**Discontinuation of ALZ2 Relay**

1. Reason: Replaced by newly released ALZ5 relay

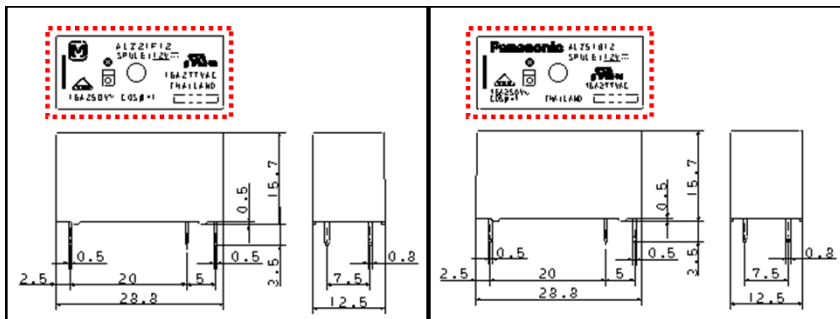
5. Product update: Removal of dummy contact (Cu); movable contact change from AgSnO<sub>2</sub> (solid) to AgSnO<sub>2</sub> (Ag+Cu bonded); housing marking change.

4. Substitution: ALZ5 relay (drop-in replacement)
